Access Compliance Report

Public Rights-of-Way

(Curb Ramps)

Intersection ID: 49322	Main Street: OLD_HOUSE_CR	Cross Street: WHITEBEAM_WY	Location: W
ADA ID: 53824306C00C	Ramp Type: Perp	Initial Pass/Fail: Fail	Overall Compliance: No
Codes/Mitigation Info/Possible Solution		Field Measurements/Component Compliance

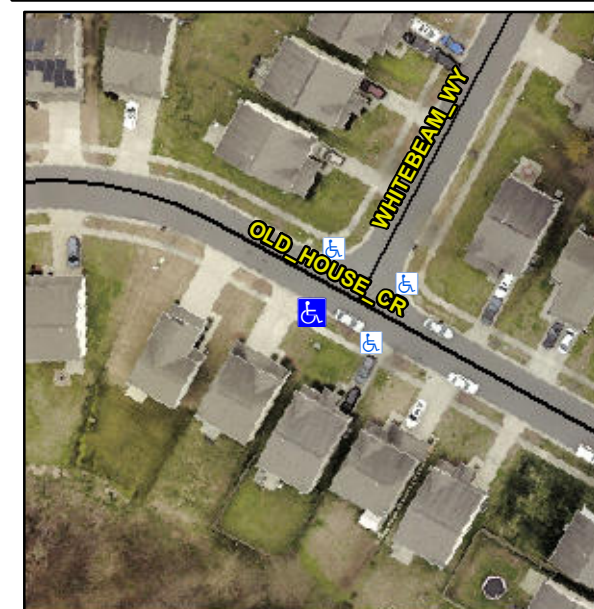
Not Found, R304.2.2, R304.5.3

Compliance	Description	Data	Compliance	Description	Data
N/A	Ramp Length (in)	70.5	No	Ramp Slope (%)	9.8
Yes	Ramp Width (in)	48.0	No	Ramp XSlope (%)	3.9
N/A	Flare Type LT	N/A	N/A	Flare Type RT	N/A
N/A	Flare Slope LT (%)	N/A	N/A	Flare Slope RT (%)	N/A
N/A	Flare Traversable LT?	N/A	N/A	Flare Traversable RT?	N/A
N/A	Landing Length (in)	N/A	N/A	DWS Provided?	N/A
N/A	Landing Width (in)	N/A	N/A	DWS Contrast?	N/A
N/A	Landing Slope (%)	N/A	N/A	DWS Length (in)	N/A
N/A	Landing X Slope (%)	N/A	N/A	DWS Full Width?	N/A
N/A	Landing Curb? (Y/N)	N/A	N/A	DWS Offset (in)	N/A
N/A	Shared Landing?	N/A			
N/A	Gutter Ponding?	N/A	N/A	Gutter Slope (%)	N/A
N/A	Gutter Lip Ht (in)	N/A	N/A	Gutter X Slope (%)	N/A
N/A	Painted X Walk1?	No	N/A	Painted X Walk2?	N/A
	X Walk 1 Direction	To NE		X Walk 2 Direction	N/A
N/A	X Walk 1 Width (in)	N/A	N/A	X Walk 2 Width (in)	N/A
	X Walk 1 Slope (%)	0.7		X Walk 2 Slope (%)	N/A
	X Walk 1 X Slope (%)	3.6		X Walk 2 X Slope (%)	N/A

Remove & Replace Entire Ramp.
